97-1, *Publication Date: JANUARY 2, 1997*

<ul style="list-style-type: none"><li>• Service Manual - Powertrain Control/Emissions Diagnosis (PC/ED) On-Board Diagnosis II (OBD II) - Cover Page Replacement To Include 1997 Vehicles With FD1060 Or FD1460 Engine</li><li>• Service Manual - Powertrain Control/Emissions Diagnosis (PC/ED) On-Board Diagnosis II (OBD II) - Cover Page Replacement To Include 1997 Windstar</li></ul>	<b>Article No. 97-1-15</b>
--------------------------------------------------------------------------------------------------------------------------------------------------------------------------------------------------------------------------------------------------------------------------------------------------------------------------------------------------------------------------------------------	--------------------------------

Article No.  
97-1-17

Figure 2 - Article 97-1-17

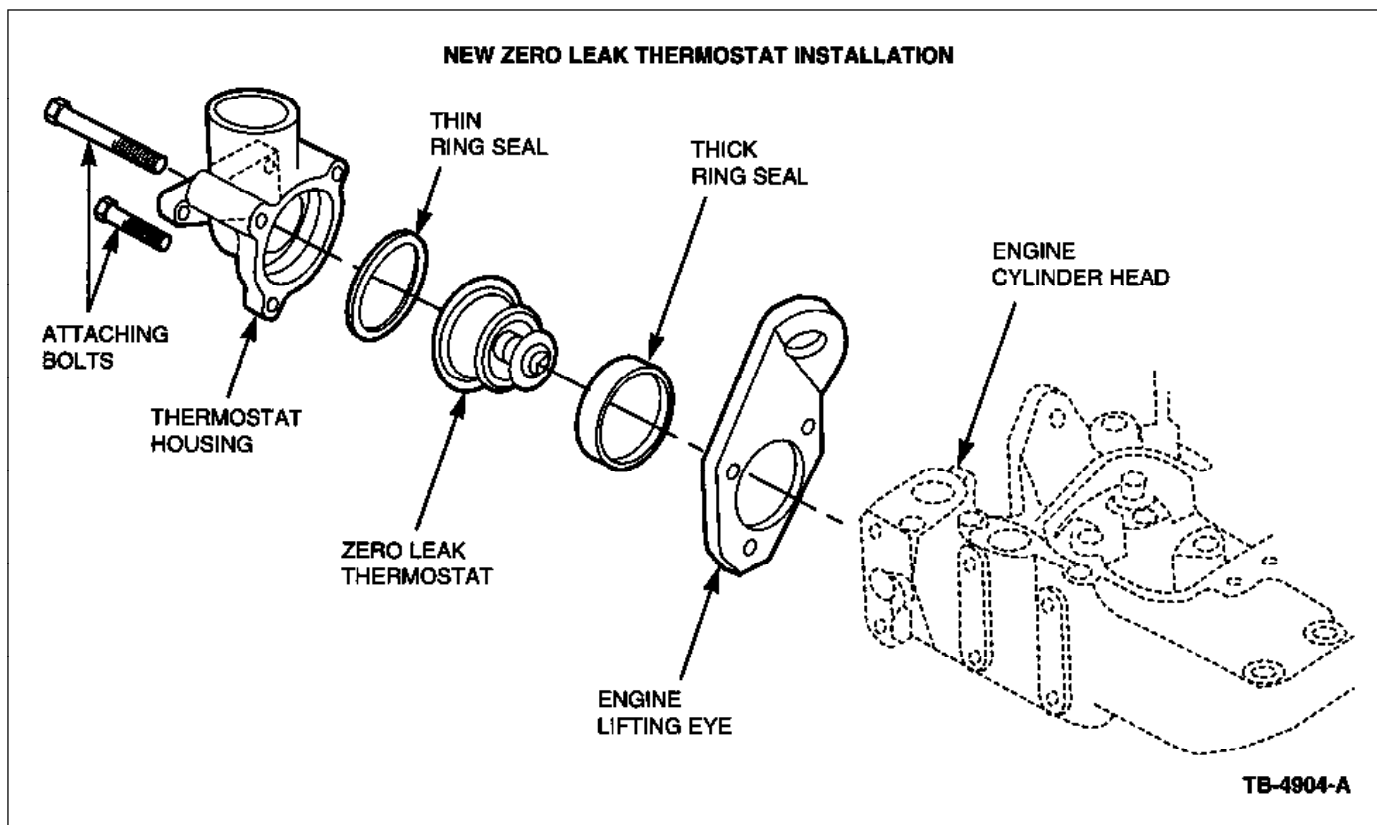
Replace the thermostat and deaeration system. The new thermostat will allow for zero bypass of the coolant which should allow the engine to warm up to operating temperature quicker. Refer to the following Service Procedure for details.

INSTEAD OF THE SINGLE THERMOSTAT GASKET, THE ZERO LEAK THERMOSTAT USES TWO (2) SEALS TO PROVIDE A SEAL FOR THE COOLING SYSTEM. A THERMOSTAT GASKET IS THEREFORE NOT NEEDED. ALSO IT IS NOT NECESSARY TO USE AN RTV OR OTHER SEALER ON THE NEW SEAL RINGS.

9. Install the existing engine lifting eye, the new thick Seal Ring (F7HZ-8255-BA), Zero Leak Thermostat (F7HZ-8575-AA), thin Seal Ring (F7HZ-8255-AA) and Thermostat Housing (F7HZ-8592-AA) onto the engine as shown in Figure 2 using the three (3) existing attaching bolts. Torque the bolts to 42-57 N-m (31-42 lb-ft).

Figure 3 - Article 97-1-17

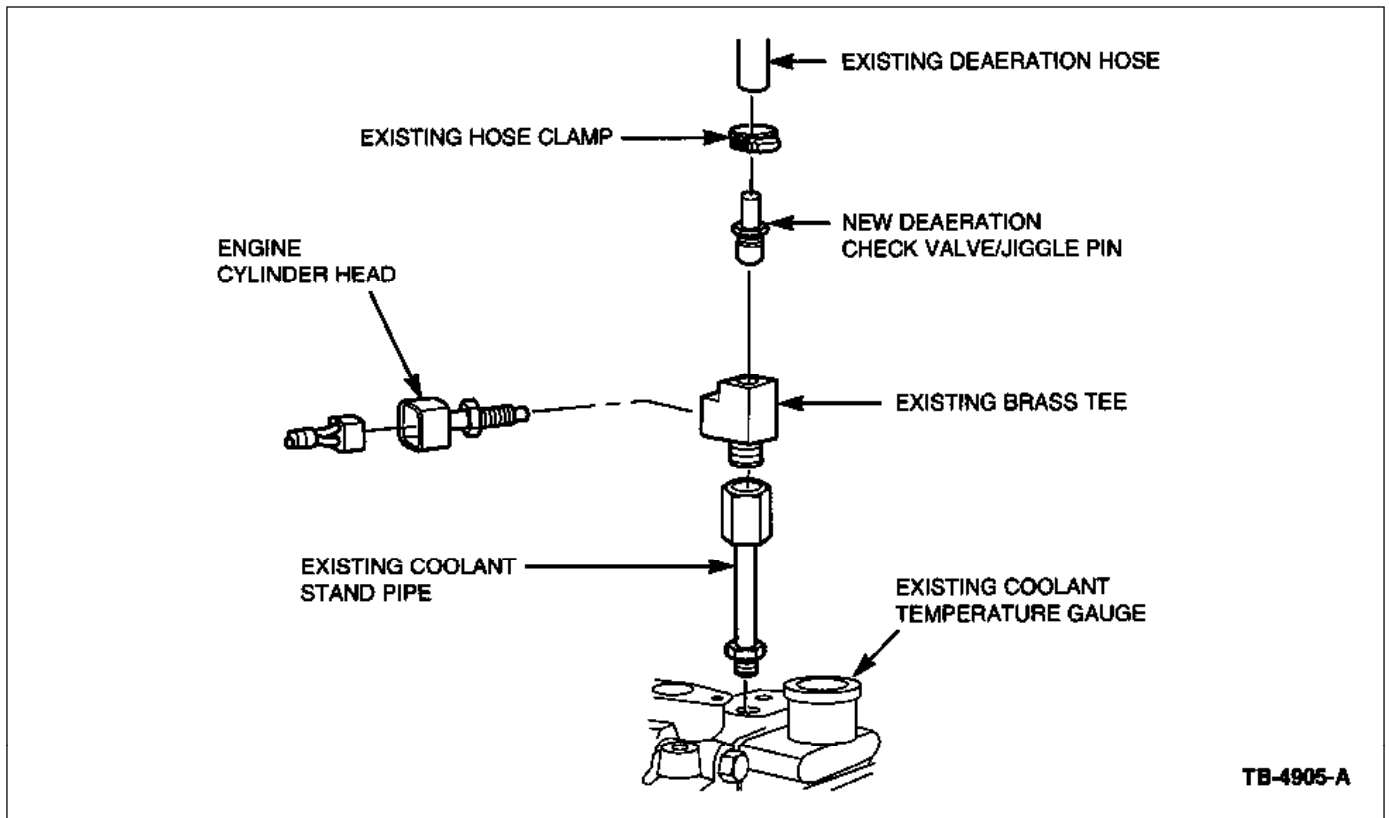
FIGURE 3 PROVIDES A VIEW OF THE DEAERATION SYSTEM AND THE ENGINE COOLANT TEMPERATURE SENDER AS IT APPEARS ON 1996-97 VEHICLES AFTER THE INSTALLATION OF THE NEW DEAERATION CHECK VALVE/JIGGLE PIN. ON 1992-95 VEHICLES, THE INSTALLATION OF THE ENGINE COOLANT TEMPERATURE SENDER VARIED. THE CHANGE WAS OUTLINED IN TSB «95-20-12». FOR THESE VEHICLES, THE COOLANT TEMPERATURE SENDER INSTALLATION SHOULD BE MODIFIED AS STATED IN TSB 95-20-12. THIS WILL PROVIDE A MORE ACCURATE COOLANT TEMPERATURE GAUGE READING.

11. Remove the existing deaeration hose barb fitting and bushing from the coolant stand pipe assembly and discard. The new deaeration check valve/jiggle pin will replace both of these components.
12. Install the new deaeration Check Valve/Jiggle Pin (3926761-CF) into the coolant stand pipe. Be sure the threaded portion of the new check valve/jiggle pin is first coated with a sealer or wrapped in a teflon tape prior to installation to reduce the possibility of coolant leaks.
13. Install the deaeration hose onto the new check valve/jiggle pin and tighten the hose clamp to 1-1.5 N-m (9-13 lb-in).
14. Reinstall and/or reposition any components removed to gain access to the thermostat housing.
15. Reinstall the negative battery cable.
16. Refill the cooling system following the procedure provided in the appropriate model/year Service Manual.

**Figure 3 - Article 97-1-18**

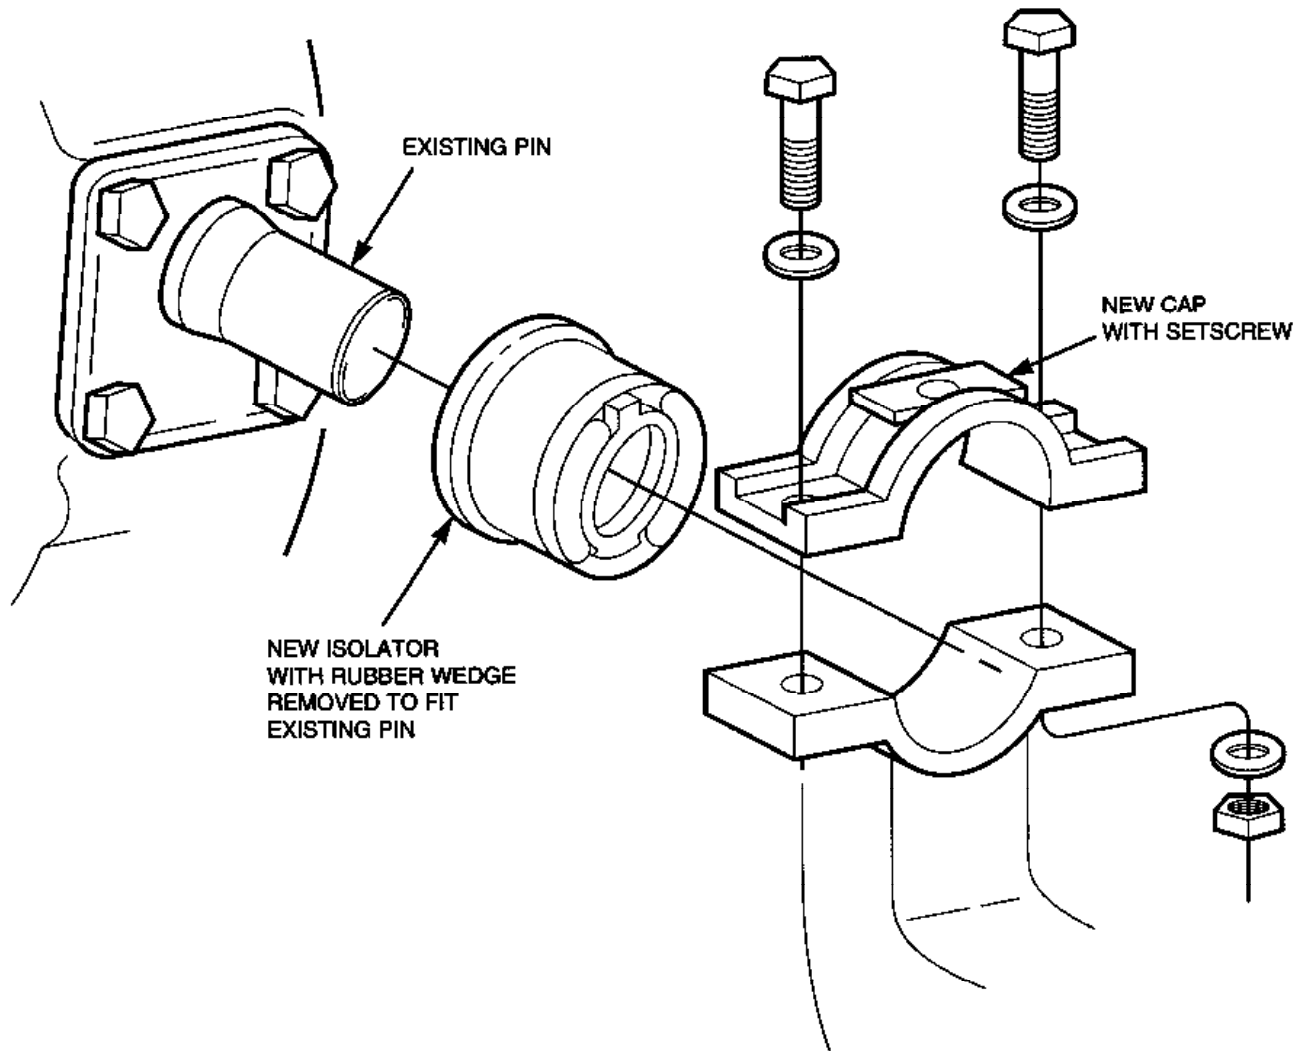
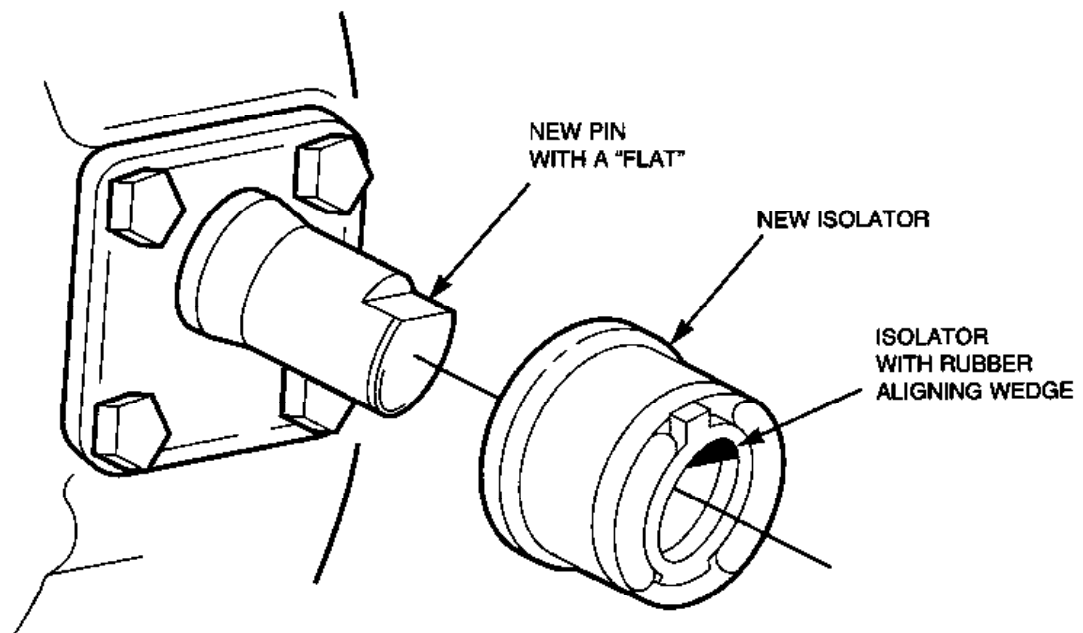
THE REVISED ISOLATORS HAVE A SELF ALIGNING FEATURE BUILT INTO THEM. IT IS A RUBBER WEDGE THAT FITS ONTO THE CORRESPONDING FLAT OF THE NEW SUPPORT PIN. THIS FEATURE AIDS THE ASSEMBLY PROCESS AND IT IS UTILIZED ON VEHICLES BUILT AFTER 10/15/96. ON VEHICLES ALREADY IN SERVICE EQUIPPED WITH THE ORIGINAL FULLY ROUND PIN, THE ALIGNING FEATURE OF THE NEW ISOLATOR MUST BE REMOVED. THIS CAN BE DONE BY CUTTING THE RUBBER WEDGE OUT USING A KNIFE. NEW SUPPORT PINS ARE NOT NEEDED.

5. Slowly lower the engine onto the revised isolators and remove the service jack and wood block.
6. Install a new cap onto each revised isolators.
7. Install the existing isolator/cap retaining bolts, washers and new Nuts (34989-S2). Torque the bolts to 102-142 N-m (75-105 lb-ft).

**Figure 2 - Article 97-4-11**

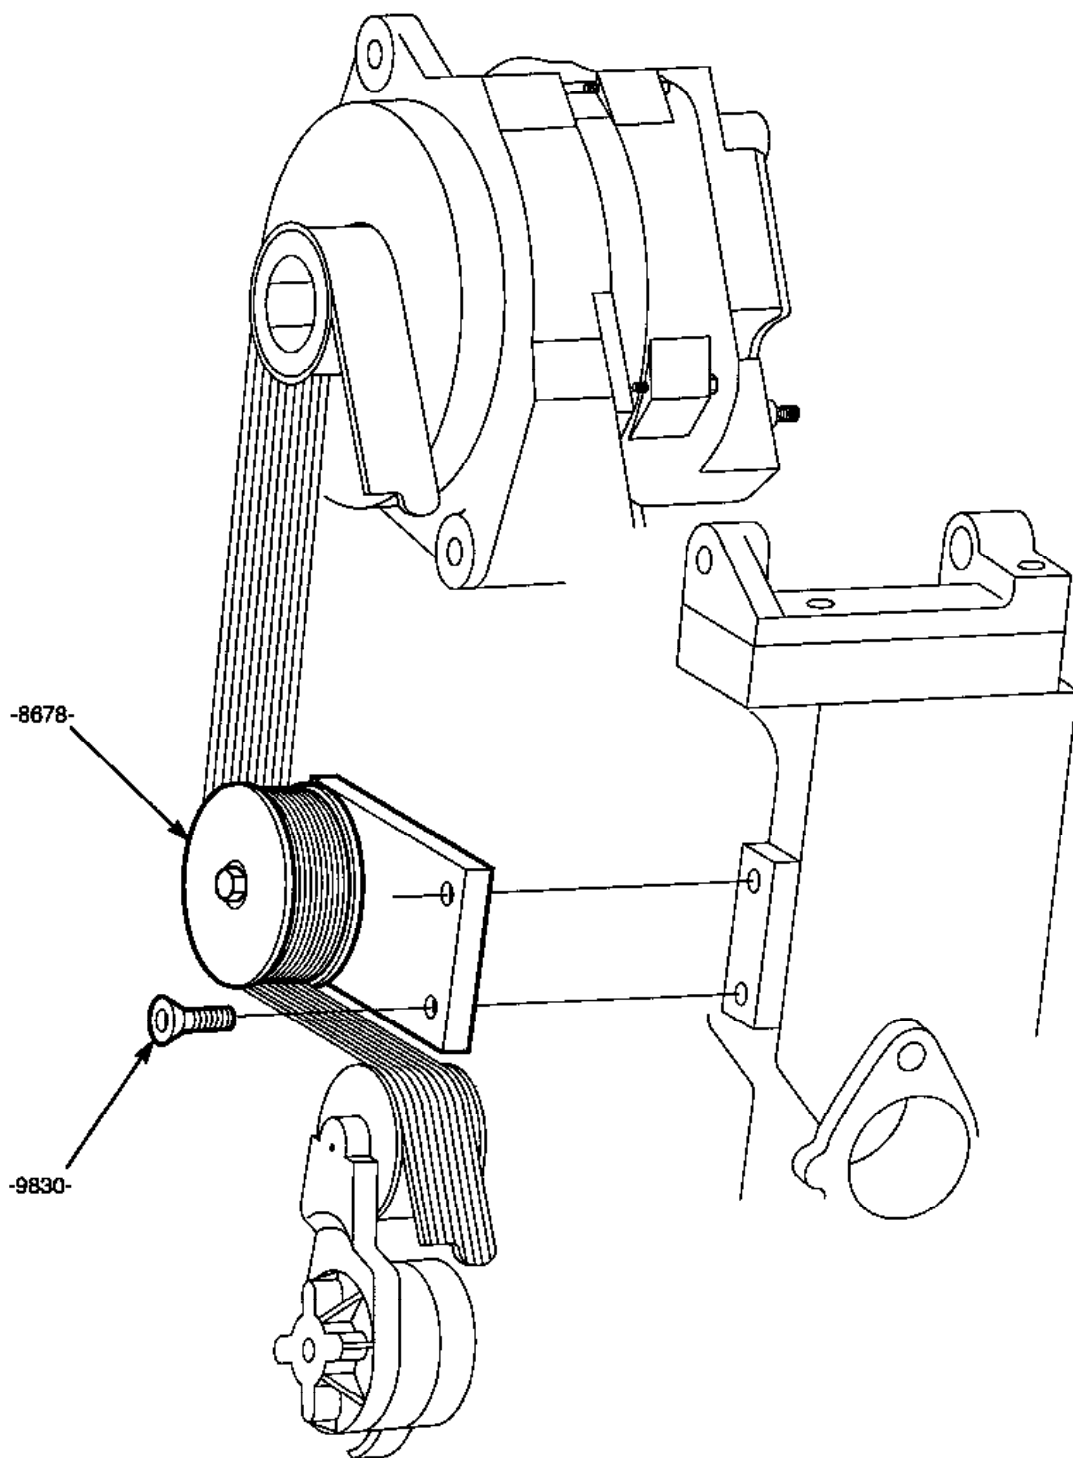
ON EARLY BUILT FD1060 ENGINES, THE TENSIONER AND IDLER SUPPORT PLATES WERE ATTACHED TO THE ENGINE WITH COUNTERSUNK BOLTS (REFER TO FIGURE 2). THE NEW IDLER AND SUPPORT PLATE ASSEMBLY NOW USES HEX HEAD FLANGE BOLTS. THEREFORE, IF AN ENGINE IS EQUIPPED WITH THE COUNTERSUNK BOLTS, THEN THOSE BOLTS MUST BE REPLACED WITH NEW HEX HEAD FLANGE BOLTS (3900631-CF).

5. Install the new automatic Belt Tensioner Support Plate (F3HZ-6B209-AAA) onto the engine with the two (2) attaching bolts. Torque the bolts to 20-32 N-m (15-24 lb-ft).
6. Install the automatic belt tensioner onto the support plate with one (1) bolt and torque to 41-52 N-m (30-38 lb-ft).
7. If the vehicle is equipped with air conditioning, proceed to Step 9. If the vehicle is not equipped with air conditioning, proceed to Step 8.
8. Remove the idler pulley and support plate assembly from the engine and discard. Install the new Idler Pulley Support Plate (F3HZ-8678-AAA) onto the engine with two (2) bolts and torque to 24 N-m (18 lb-ft). Refer to Figure 2.

**Figure 2 - Article 97-10-11**

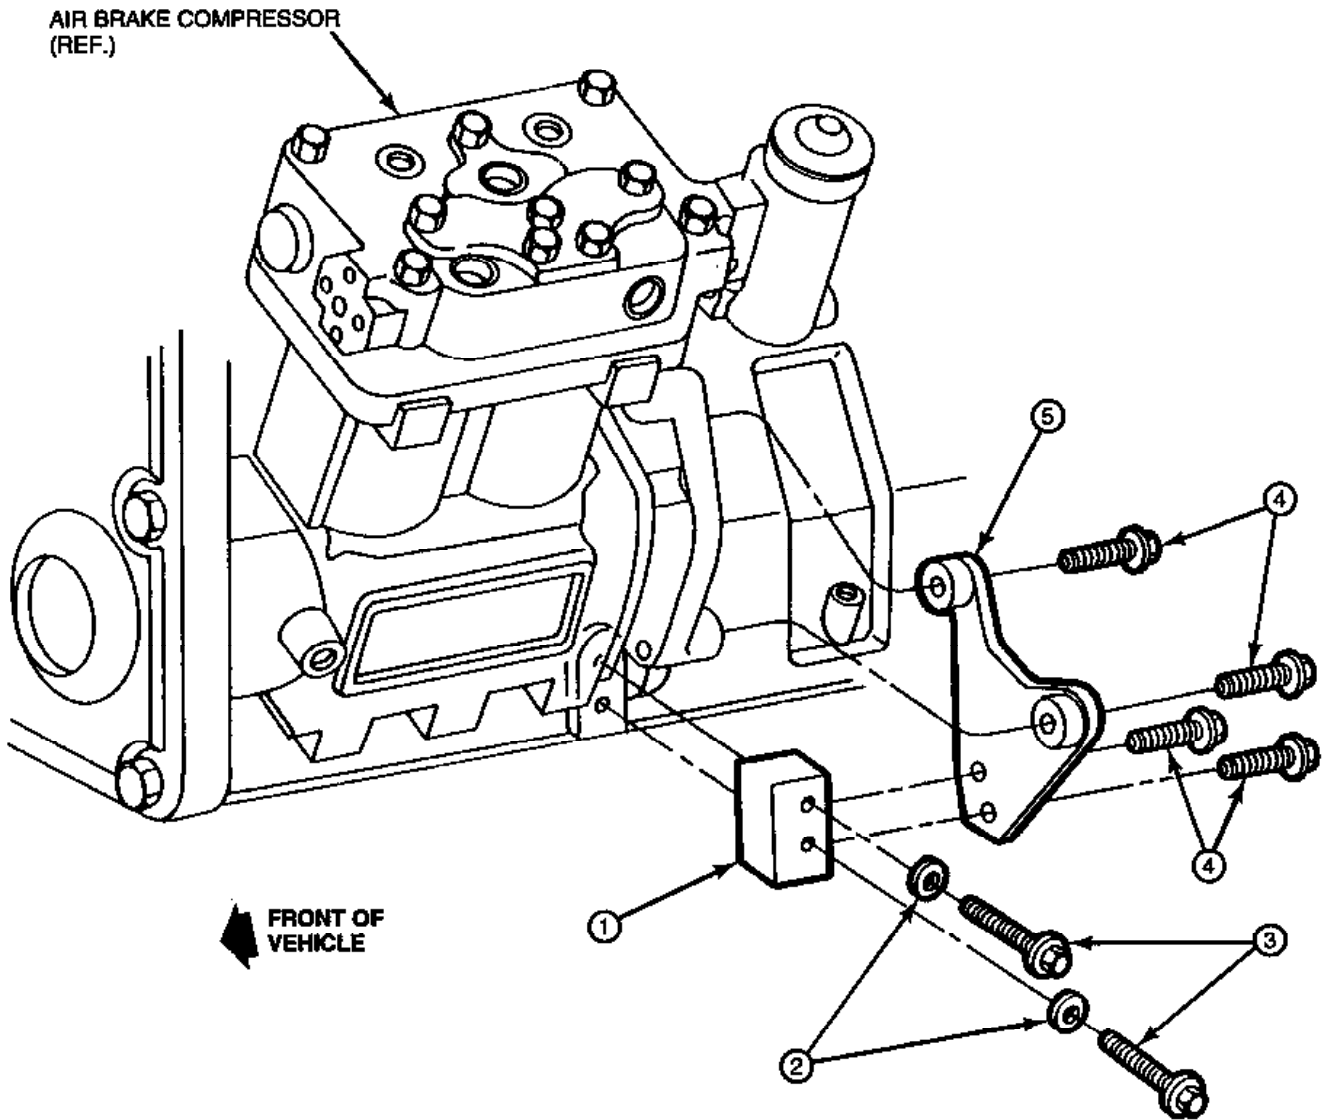
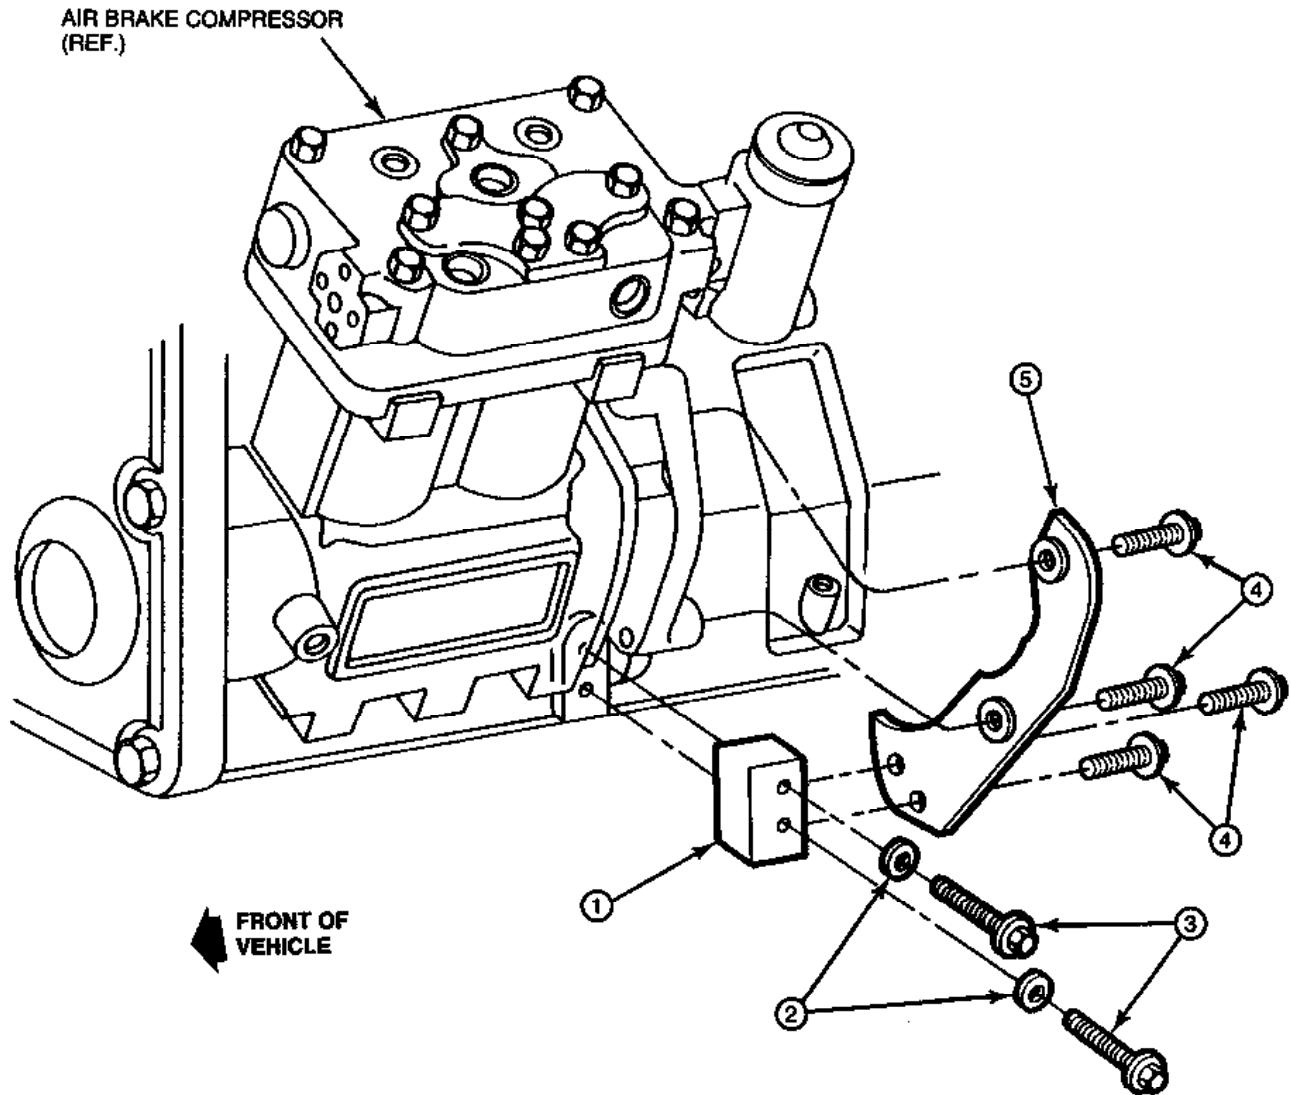
Replace the rear air brake compressor support bracket with a new bracket. The new bracket will provide additional support to reduce the possibility of oil leakage. Refer to the following Service Procedure for details.

1. Remove and discard the existing air compressor support bracket and the four (4) bracket retaining bolts.
